Class II Permissive Change Letter

Date: Jul. 13, 2021

FCC ID: **XMF-MID7018**

Change to
PCB of 6.95 inch

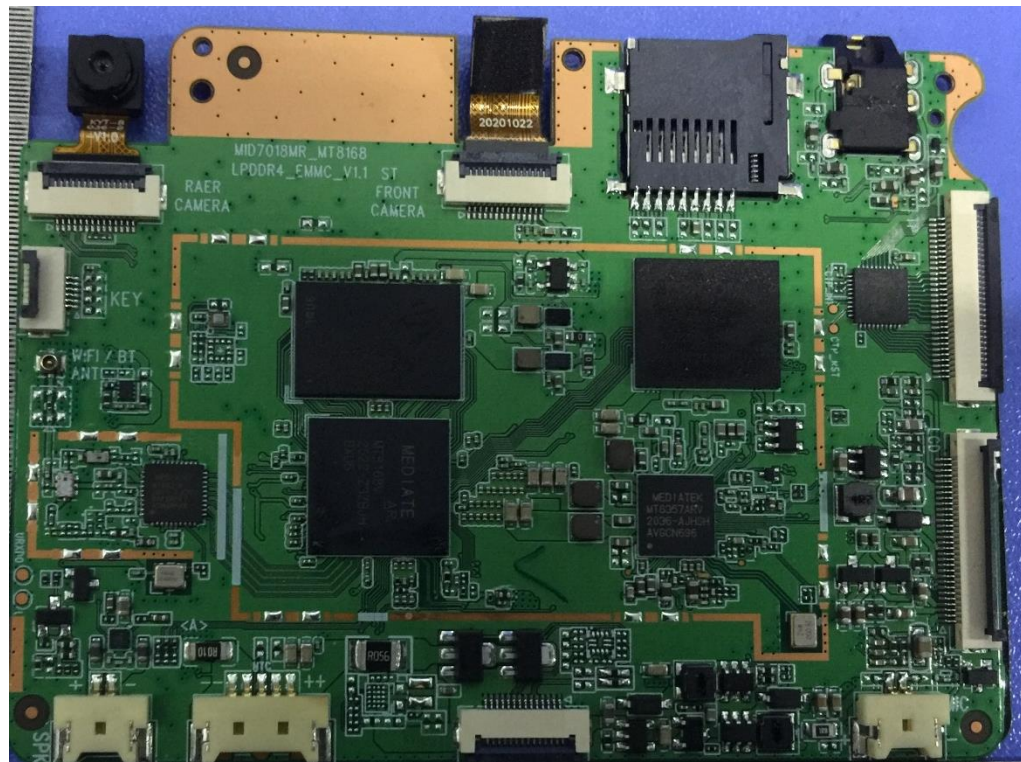
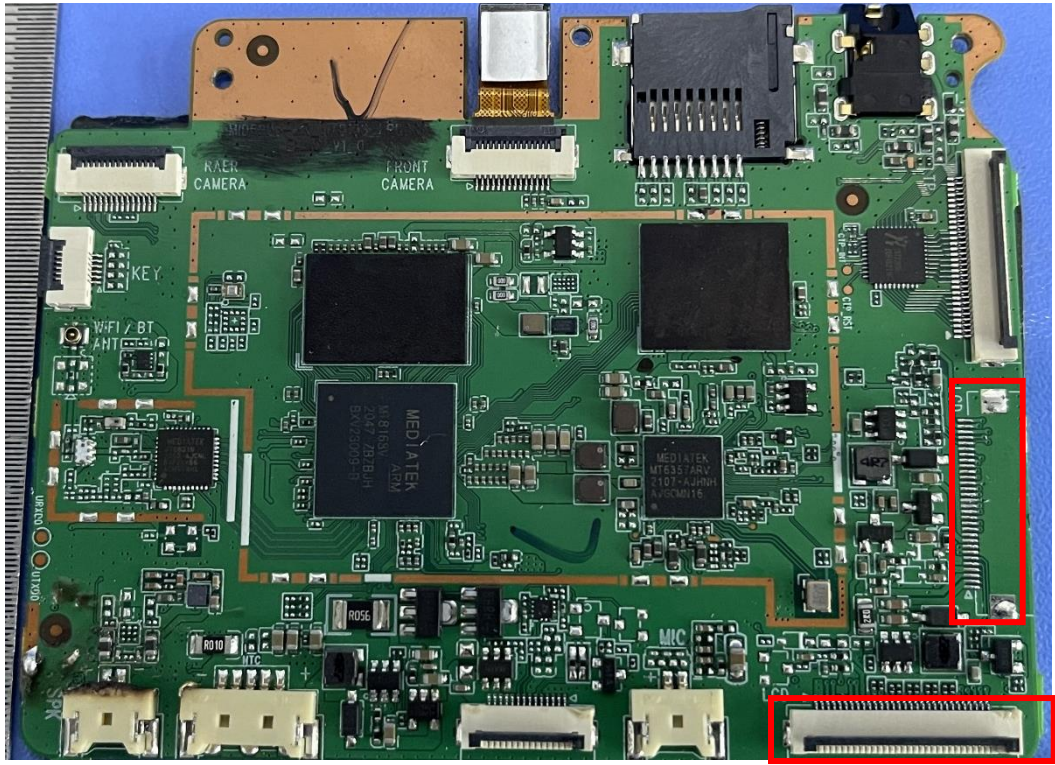
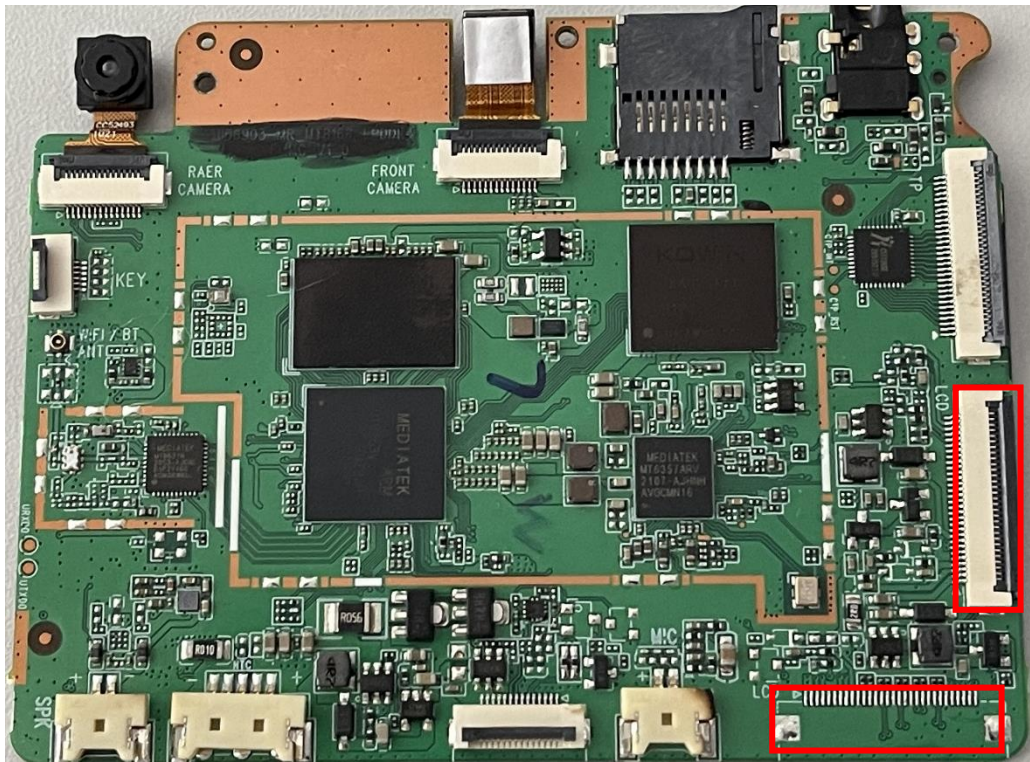
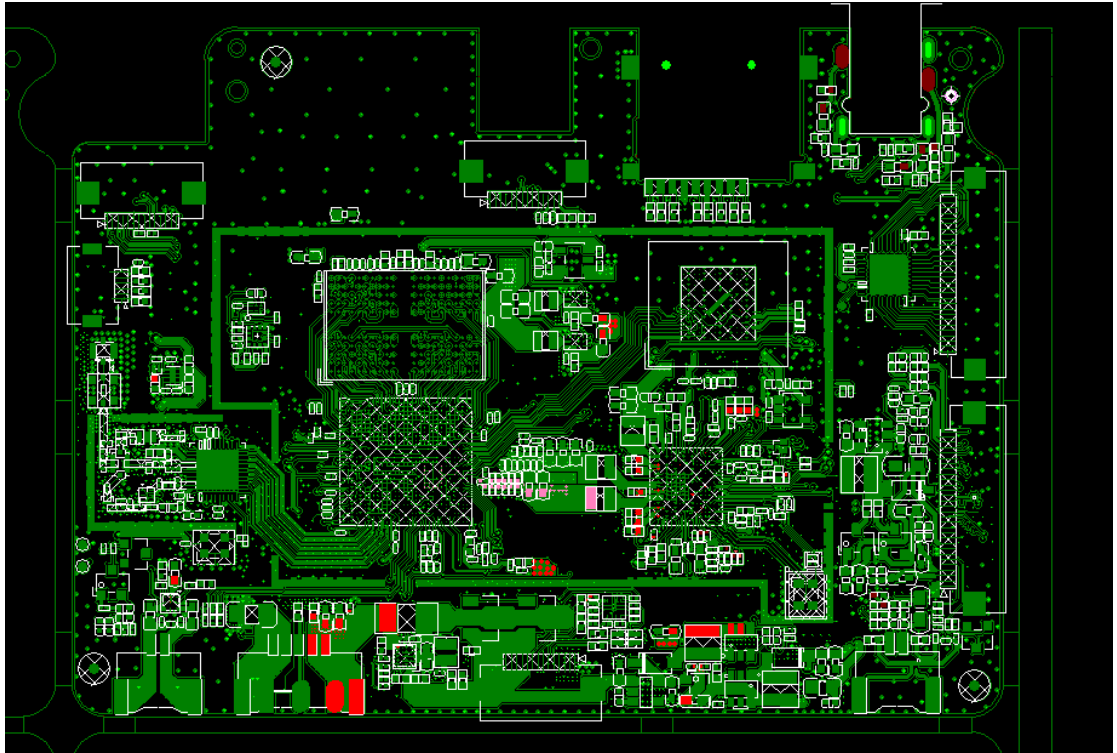
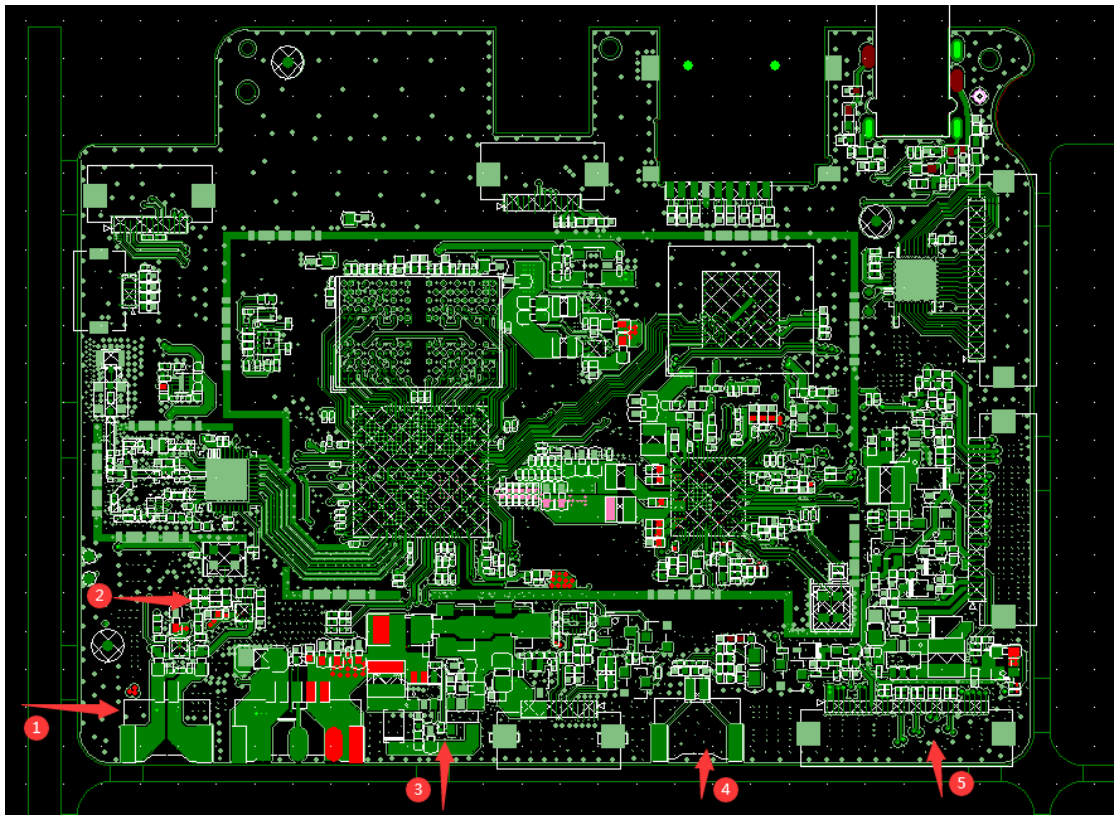
We, the undersigned, hereby attest to the fact that we will apply the class II change. The hardware of this equipment is electrically identical with original, only the follow changes to the original but still compliance of relevant standard. There is **only change of non-transmitter portions**, Field Strength of Spurious Radiation testing & SAR was performed to demonstrate RF compliance

- 1, The width of the board card is 3mm, and the positions of the speakers, batteries and USB adapter sockets are moved down.
- 2, Add compatible loudspeaker power amplifier.
- 3, Remove previously compatible unused charging ICs and move the OTG function circuit over.
- 4, MIC socket moved to the center.
- 5, Added 6.95-inch screen interface.
